AO 2007-151

AN ORDINANCE AMENDING ANCHORAGE ZONING ORDINANCE 94-235 (S-1)(AA), AN ORDINANCE THAT REZONED TO PC (PLANNED COMMUNITY) DISTRICT AND MASTER DEVELOPMENT PLAN FOR TRACT A OF THE POWDER RESERVE, MODIFYING THE PRINCIPAL CIRCULATION REQUIREMENTS FOR ACCESS AND STREET CIRCULATION REGARDING INTERNAL COLLECTOR ROAD STANDARDS AND TO INSERT REFERENCES TO TITLE 21 AND THE CURRENT MUNICIPAL DESIGN CRITERIA MANUAL (DCM) STANDARDS FOR COLLECTOR STREETS, GENERALLY LOCATED WITHIN 126+- ACRES SOUTH OF EKLUTNA PARK DRIVE, CONTAINING DEVELOPMENT AREAS M, N, O, P AND Q, GENERALLY LOCATED IMMEDIATELY SOUTHWEST OF THE NORTH EAGLE RIVER INTERCHANGE OF THE NEW GLENN HIGHWAY, LOCATED WITHIN PORTIONS OF SECTIONS 2, 35 AND 36, T15N, R2W, S.M., ALASKA.

# REZONE AMENDMENT 2007-069

Figure 13. PC District Residential Street Design Standards.

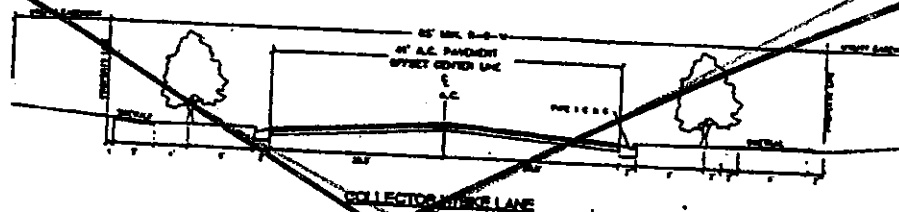
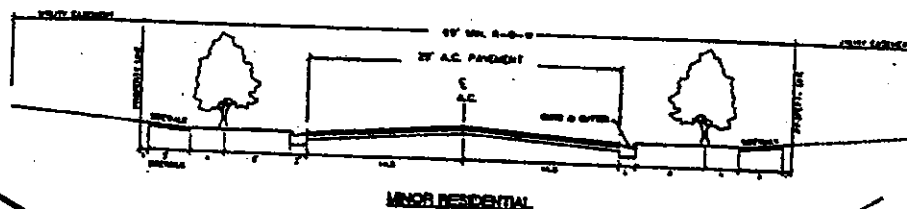
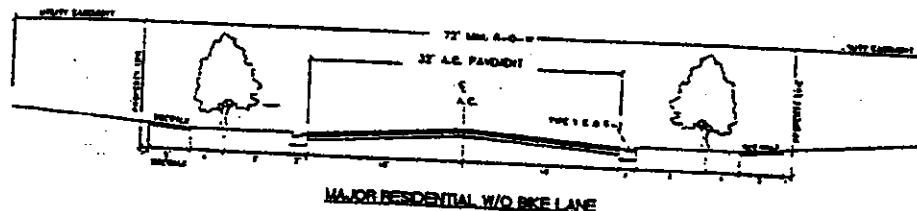
Page 40, Illustration Figure 13, PC District Residential Street Design Standard for Collector w/Bike Lane and Collector w/o Bike Lane, is deleted in its entirety.

- c. Illustration Figure 13 will be deleted: PC District Residential Street Design Standard for Collector w/Bike Lane and Collector w/o Bike Lane.
